IDAHO DEPARTMENT OF WATER RESOURCES

--- DAM SAFETY RECORD OF INSPECTION ---

Name of Dam: Twin Lakes

Date: 06/06/2013

Photo 5 - (06/06/2013) - Right Pier Crack at Gate Centerline

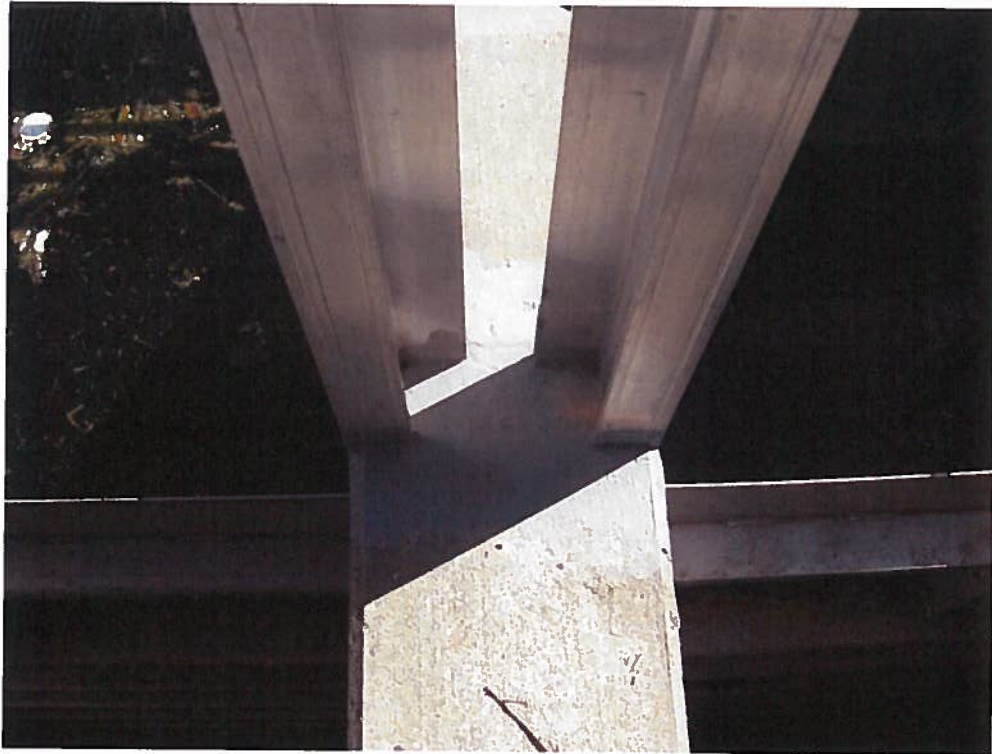
Reportedly, the center gate has failed two time in recent years, and the electric motor was replaced in 2010. According to the dam tender, hydraulic induced vibration tore the aluminum center gate "like paper". The gate was replace with like and failed a second time. The second replacement was with a stainless steel gate. The left and right gates are still aluminum, but reportedly were reinforced some during the last replacement of the center gate in 2010. The right gate is reported to be currently inoperable (Photo 3) due to possible problems with the manual crank mechanism. The Dam Tender reports that he has never fully exercised the gates. The gate manufacturer in the 2005 Operations Plan call for gate operation every three months. Also, a crack perpendicular to the direction of flow formed in the concrete abutment and piers after construction. The crack follows the axis of the gates' alignment (Photos 4,5,6,7). The Dam Tender has filled the cracks with sealant.

5. Monitor the crack in the concrete abutment and piers for continued displacement. Make repairs as necessary. Keep the crack sealed to prevent corrosion of the reinforcing steel and embedments.
